AGENDA
BOARD OF ZONING APPEALS
Thursday, October 8th, 2026
1:00 P.M.
CITY HALL COMMON COUNCIL CHAMBERS

<i>V-2026-18</i>	<i>Staff Report – October 8th, 2026</i>				
<i>Application Type:</i>	Area Variance				
<i>Project Address:</i>	316 Delaware Street (Tax Map IDs: 092.-09-25.1)				
<i>Summary of Proposed Action:</i>	The applicant proposes a transparency variance in ground floor, land use is “dwelling, multi-unit”. The proposal contains 29 residential units. As the parcel has 1 primary street frontage and two secondary street frontages, the applicant proposes 21.88% ground-floor transparency along the primary street frontage at south side of the building along Delaware Street, 8.5% secondary street frontage at East side of the building along the Kellogg St., 20.7% secondary street frontage at West side of the building along Grace St., requiring an Area Variance relief of transparency. As multi-dwelling residential structures with four or more units are required to provide a minimum of 30% transparency (windows and door openings) on the ground-floor façade facing a public street. Dwelling multi-units land use types are permitted by right under the regulations of the R-5 Zone Distric

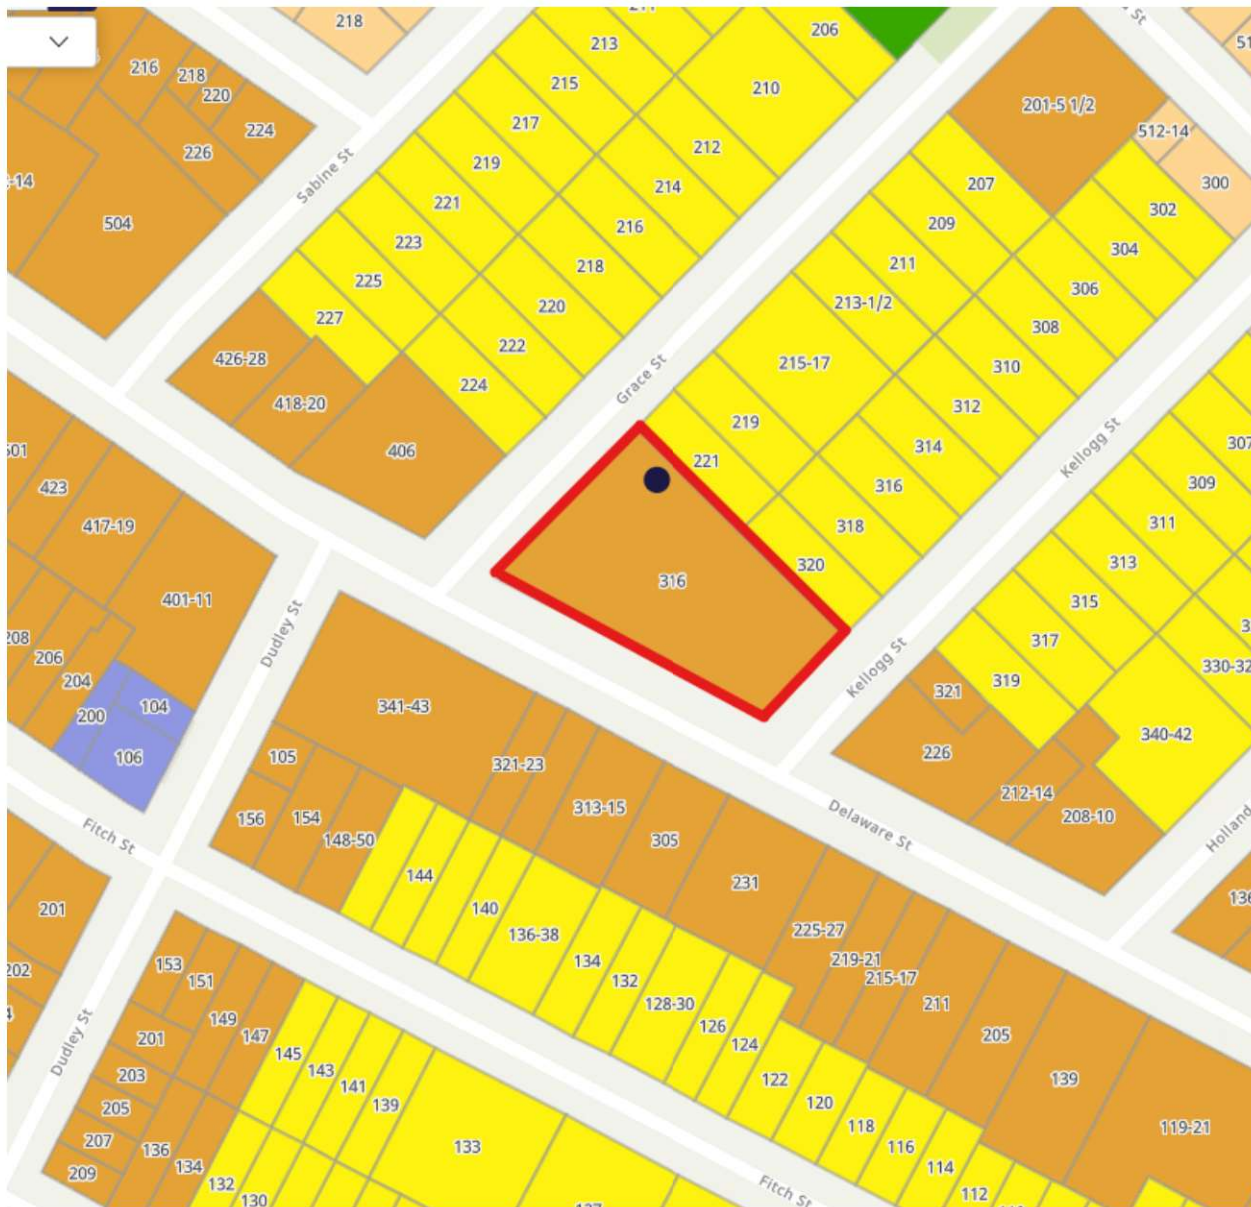
<i>Staff Analysis:</i>	<u>Staff Analysis of Area Variance Approval Criteria</u> <u>Neighborhood Character (Criteria Met):</u> The proposed reduction in first-floor transparency from 30% to 21.88% at south side, 20.7 at West Side and 8.5 at East side will not produce an undesirable change in the character of the neighborhood or create a detriment to nearby properties. The proposed multi-dwelling residential building aligns with the scale, density, and physical context of the surrounding R-5 zone district. <u>Feasibility of Alternatives (Criteria Met):</u> A feasible alternative to achieve the required 30% at first-floor transparency does not exist. The applicants design placed bedroom windows along Delaware Street and Kellogg Street, while the remaining portions of the units contain bathrooms, and storage areas that cannot accommodate additional fenestration. Increasing window area would require a full redesign of the unit layouts and would disrupt the established architectural rhythm of the façade, which is based on brick tower elements and proportional window placement. Therefore, strict compliance with 30% transparency requirement is not feasible without compromising the functional layout and architectural integrity of the building. As per SZO Article 7.3, A.(1) C. a lesser amount may be allowed if limited by state and/or local energy codes. <u>Substantiality (Criteria Not Met):</u> The requested variance is substantial. The proposed 21.88% at Delaware St. (this is a primary street frontage and all the units are placed along this frontage), 20.7% at Grace St.(this side is secondary street frontage and community room, maintenance storage and mechanical room is located) and 8.5% at Kollege St. (this is also

secondary street frontage that two units are located at this side which they already have transparency from primary side also). Overall average in three side of ground floor transparency is 17% represents a significant deviation from the required 30% standard, maintaining visual interest and architectural modulation along the street front. Adverse Effect (Criteria Met): The requested area variance (21.88, 20.7, & 8.5 % provided out of 30% transparency) will not have an adverse physical or environmental effect on the neighborhood. The site incorporates 15 off-street parking spaces, adequate landscaping, and proper site screening to mitigate any physical impacts. Self-Created Difficulty (Criteria Not Met): While the difficulty is technically self-created, resulting from the applicant's architectural design choices and the decision to incorporate a modern façade with reduced ground-floor transparency, this factor alone does not preclude approval of the variance. The transparency deficiency does not create any adverse physical, environmental, or community impacts, nor does it alter circulation, access, or neighborhood character.

Staff Recommendation:	Staff recommend approving this project as proposal meets three criteria.
Recommend conditions if approved:	1. The applicant shall comply with the general conditions for approval on the Variance application. (See the attached sheet General Conditions for Variance Approval) 2. The proposed Area variance only grants the "Ground floor transparency 8.12% conflict along Delaware Street at South side of the building along Delaware St.", 9.3% conflict along Grace Street at West side of the building and 21.5% conflict along Kellogg Street at East side of the building. In the 316 Delaware St. The applicant shall submit an additional Variance application if they intend to expand the proposed nonconformity.
Summary of Zoning History:	C-0167 Conditional Use for a funeral home denied on 4/5/1944 R-23-53 Resubdivision to Merge 6 lots (304, 310-312, 316, 320, 322-326, Delaware St, and 223 Grace St) into one new lot approved on 9/1/2023 <u>316 Delaware St:</u> (old lot before Resubdivision): No zoning history, vacant lot, house demolition finished 10/1/2021. <u>322-26 Delaware St:</u> no zoning history, vacant lot, demolition completed on 6/24/2022 <u>223 Grace St:</u> no zoning history, vacant lot, demolition of a two-family house completed on 7/21/2022
